PSB#071785
Stabilizer Modification to Vector Tandem Canopies
July 17, 1985

NEW NOTICE: SUPERSEDES BULLETIN DATED 5/23/85 Bulletin 7/17/85 Stabilizer Modification to Tandem Vector Canopies This bulletin advises you to modify the Vector Tandem Main Canopy and Vector Tandem Reserve Canopy before the next jump on the system. These canopies must open reliably and softly at speeds of 35 to 180 mph while carrying from 100 to 400 lbs, when the canopy is new as well as after 200 jumps. This requires a delicate balance of all the factors that affect opening shock.

FINISHED MODIFICATION

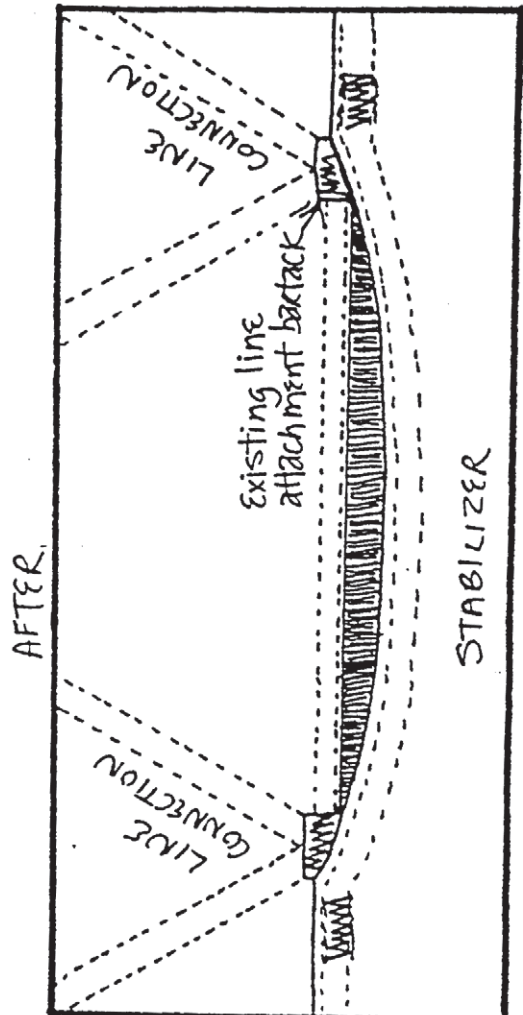
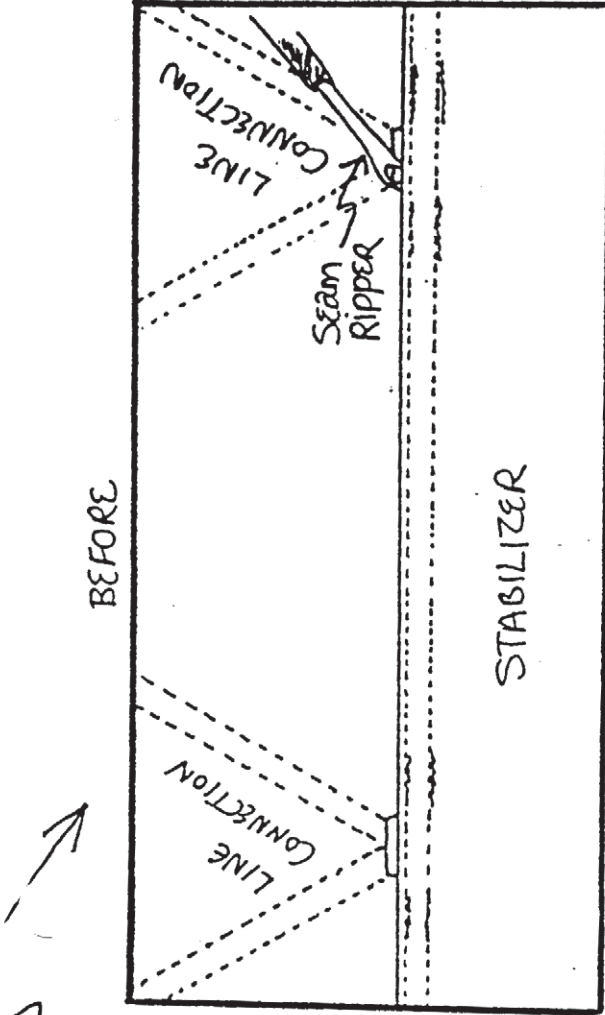
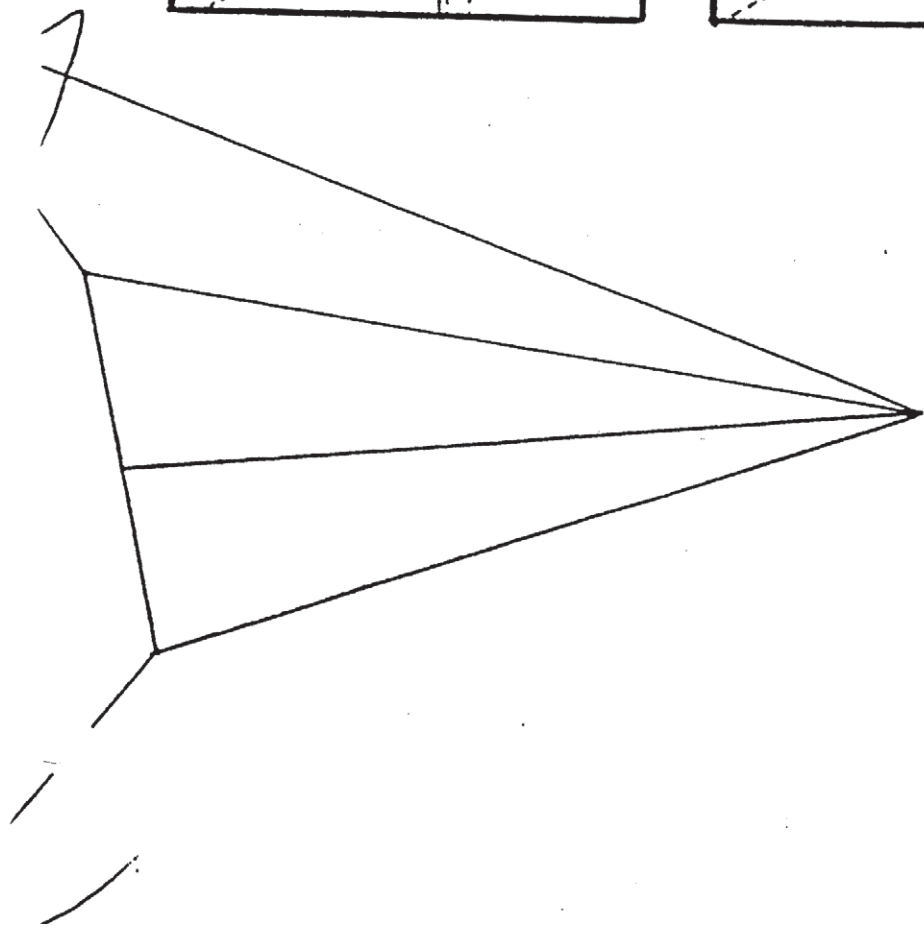
After considerable testing, the Relative Workshop has concluded that these canopies open more softly and are less likely to be damaged if they have completely slotted stabilizers Completely slotting the stabilizers gives the softest openings, while sewing them completely shut results in the best landing flare.

But experience has shown that new canopies with completely sewn up stabilizers occasionally open end-cell first, causing hard openings and canopy damage. Completely slotting the stabilizers seems to alleviate this problem.

Therefore, you must completely slot the stabilizers on both the main and reserve Tandem Vector Canopy. Because this is critical to flight safety, this must be done before the next jump

Procedure: The stabilizer is sewn to the canopy after the canopy's end rib and bottom skin are sewn together. This means the stabilizer can be detached from the canopy without affecting the seam that joins the rib and skin. When ripping the seam that attaches the stabilizer to the canopy, be careful not to damage any other seam.

1. Carefully remove the double seam that connects the stabilizer to the canopy. Be sure you have the correct seam.
2. Using a zig-zag or bartack stitch, reinforce the stabilizer attachment point at both ends of the slot with a 1-inch bartack or zig-zag. This 1-inch reinforcing must be placed next to (outside of) the existing bartack at the line attachment points, not over it. Be sure not to bartack above the top stitching of the seam (see illustration).

3. Repeat this procedure on the other side of the canopy.
4. Inspect the completed work, log and return the enclosed form. MAKE SURE YOUR BRAKES ARE SET AS PER THE ENCLOSED "BRAKE SETTING MODIFICATION" BULLETIN. PLEASE NOTE: In contradiction to the last paragraph on page 6 of that bulletin, use the upper (deep) brake setting under all conditions, regardless of weight and time of delay, or the first 100 jumps on a new canopy. See the enclosed "Tandem Canopy Break-In" sheet.
